Access Compliance Report

Public Rights-of-Way

(Curb Ramps)

Intersection ID: 14556	Main Street: E_WORTHINGTON_AV	Cross Street: WINTHROP_AV	Location: W
ADA ID: FEBB276AF684	Ramp Type: Perp	Initial Pass/Fail: Fail	Overall Compliance: No
			Severity Score: 10

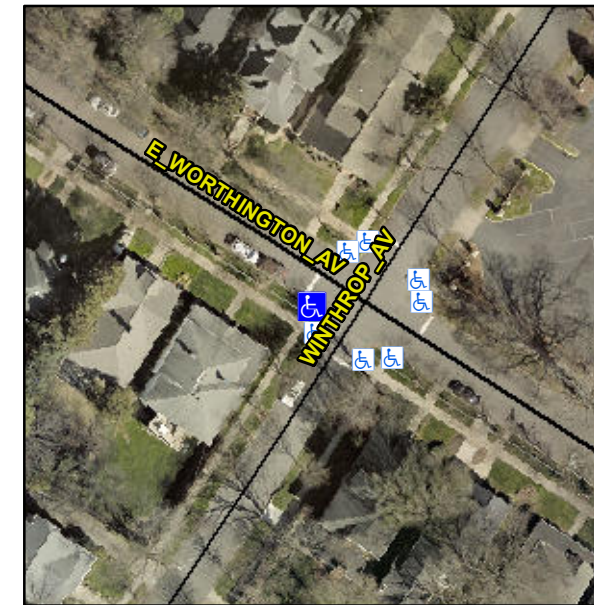
R304.5.1, R304.5.3

Compliance	Description	Data	Compliance	Description	Data
N/A	Ramp Length (in)	115.0	Yes	Ramp Slope (%)	8.3
No	Ramp Width (in)	47.0	No	Ramp XSlope (%)	2.5
N/A	Flare Type LT	N/A	N/A	Flare Type RT	N/A
N/A	Flare Slope LT (%)	N/A	N/A	Flare Slope RT (%)	N/A
N/A	Flare Traversable LT?	N/A	N/A	Flare Traversable RT?	N/A
N/A	Landing Length (in)	N/A	N/A	DWS Provided?	N/A
N/A	Landing Width (in)	N/A	N/A	DWS Contrast?	N/A
N/A	Landing Slope (%)	N/A	N/A	DWS Length (in)	N/A
N/A	Landing X Slope (%)	N/A	N/A	DWS Full Width?	N/A
N/A	Landing Curb? (Y/N)	N/A	N/A	DWS Offset (in)	N/A
N/A	Shared Landing?	N/A			
N/A	Gutter Ponding?	N/A	N/A	Gutter Slope (%)	N/A
N/A	Gutter Lip Ht (in)	N/A	N/A	Gutter X Slope (%)	N/A
N/A	Painted X Walk1?	No	N/A	Painted X Walk2?	N/A
	X Walk 1 Direction	To NE		X Walk 2 Direction	N/A
N/A	X Walk 1 Width (in)	N/A	N/A	X Walk 2 Width (in)	N/A
	X Walk 1 Slope (%)	6.8		X Walk 2 Slope (%)	N/A
	X Walk 1 X Slope (%)	0.7		X Walk 2 X Slope (%)	N/A

Remove & Replace Entire Ramp.
